Re: S/D 97-13 - WILSON FARMS ADDITION (Final Plat)

Re: S/D 97-13 - WILSON FARMS ADDITION (Final Plat)

STAFF REPORT

CASE NUMBER: S/D 97-13 - WILSON FARMS ADDITION

VICINITY MAP:

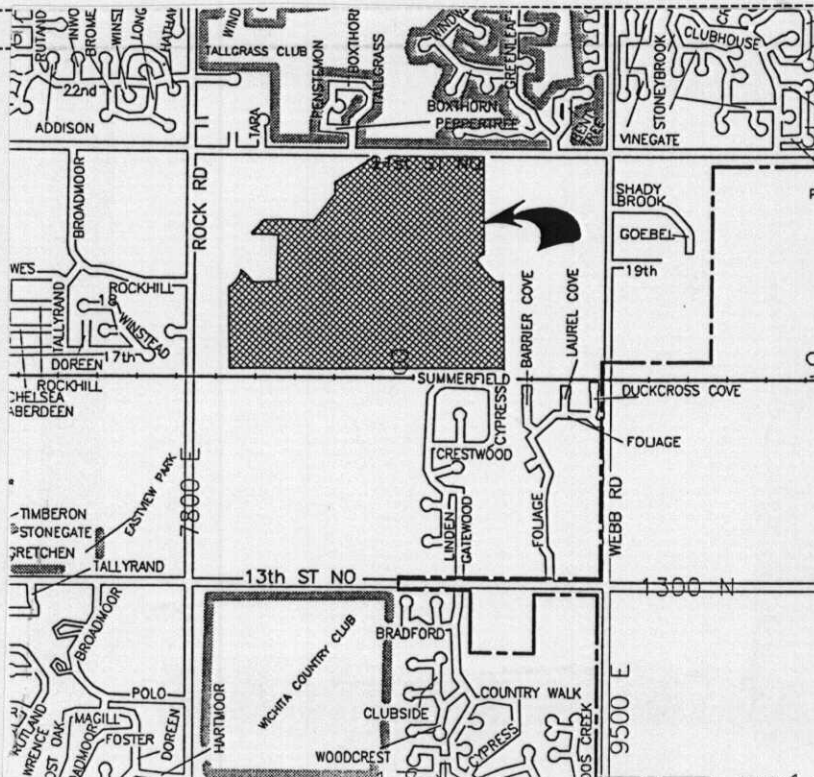
call Vicki all petitions
in and out 100%
